General Plan Conformity

DEER VALLEY VILLAGE
COUNCIL DISTRICT: 1

APPLICANT'S NAME: Diversified Future		REQUESTED CHANGE:	
APPLICATION NO: Z-120-26-1		FROM: S-1 (5.03 ac.)	
DATE: 8/17/2026		TO: R1-10 (5.03 ac.)	
REVISION DATES:			
AERIAL PHOTO & QUARTER SEC. NO. QS 50-21			
ZONING MAP P-6			
GROSS AREA INCLUDING 1/2 STREET AND ALLEY DEDICATION IS APPROX. 5.03 Acres			
MULTIPLES PERMITTED S-1 R1-10		STANDARD OPTION 5 17	
		* UNITS P.R.D OPTION N/A 22

33RD AVE & OBERLIN WAY-EAST
CONCEPTUAL SITE PLAN
A.P.N. 205-02-009A
PHOENIX, ARIZONA

Conceptual Site Plan, Source: Diversified Future

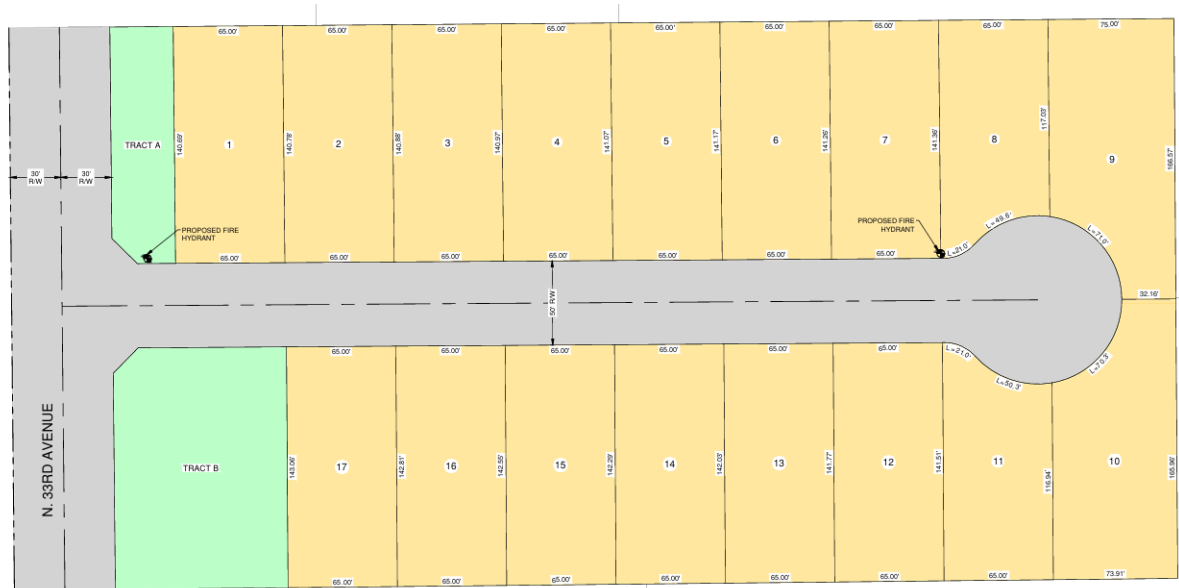
* While 8.92 percent open space exceeds the minimum 5 percent requirement, it is unclear if the configuration of the common open space meets the requirements of the Phoenix Zoning Ordinance.

1. The development shall be limited to 17 lots.
2. Minimum 5-foot-wide detached sidewalks separated by minimum 5-foot-wide landscape strips located between the back of curb and sidewalk shall be constructed on both sides of all streets within the subdivision, including the east side of 33rd Avenue, planted to the following standards, and as approved by the Planning and Development Department.
 - a. Minimum 2-inch caliper, single-trunk, large canopy, drought-tolerant, shade trees, planted 20 feet on center, or in equivalent groupings, planted on both sides of the sidewalk, to provide a minimum of 75% shade.
 - b. A minimum of five, 5-gallon drought-tolerant shrubs per tree, and aA mixture of drought-tolerant shrubs, accents, and vegetative groundcovers, with a maximum mature height of two feet, evenly distributed throughout the landscape area to achieve a minimum of 50% live coverage.
